Access Compliance Report Public Rights-of-Way (Curb Ramps)

Main Street: CRESTKNOLL_DR Cross Street: GLENKNOLL_DR Location: SE

ADA ID: RPAT210923085926 Ramp Type: Type 3 - Combination 1 Initial Pass/Fail: Fail Overall Compliance: No Severity Score: 4

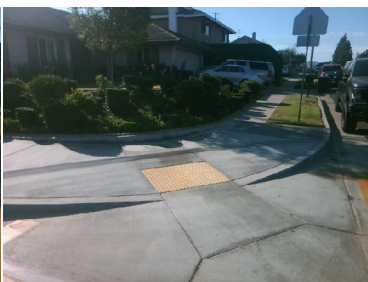
R304.2.2, R304.5.1, STD 1115

Remove & Replace Curb Ramp With Two New Directional Ramps or Equivalent. Remove & Replace Sidewalk.
